ADDENDUM NO. 1

3RD ST AND WALNUT ST RECONSTRUCTION

VILLAGE OF ANNA, OHIO

Project No. 224884.01

ELECTRICAL CONDUIT DETAIL

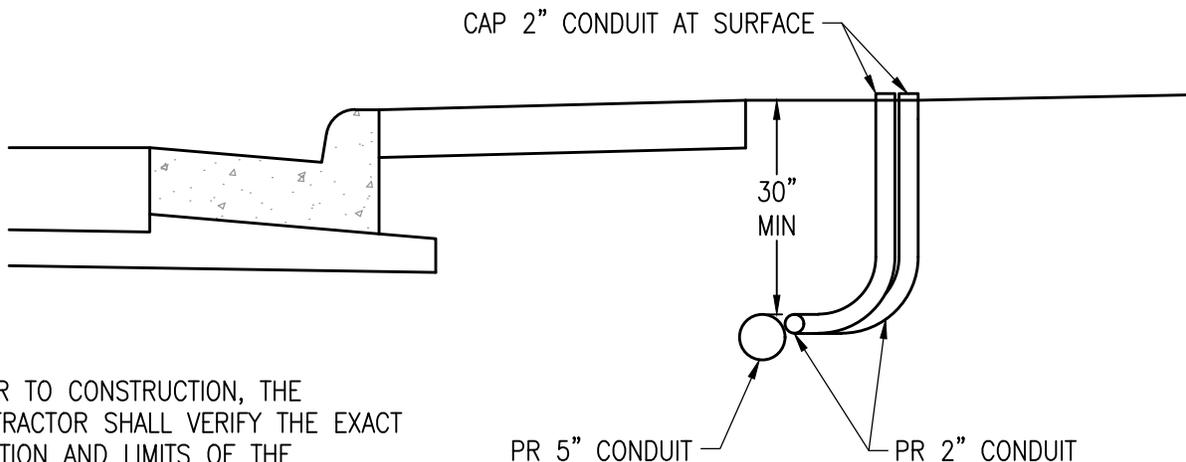
For Key Notes 14 and 15 on plan sheets 6-10 \ 26, install the 2" conduit adjacent to the 5" conduit from STA 0+80 to STA 7+95. Stub the 2" conduit for future light poles. Continue the 2" conduit from STA 7+95 to STA 13+90 and stub for future poles as shown. Detail attached to addendum

- A. PRIOR TO CONSTRUCTION, THE CONTRACTOR SHALL VERIFY THE EXACT LOCATION AND LIMITS OF THE PROPOSED ELECTRICAL CONDUIT WITH THE VILLAGE.
- B. ALL CONDUIT SHALL BE UL RATED BURIED WITH A MINIMUM 30" OF COVER.
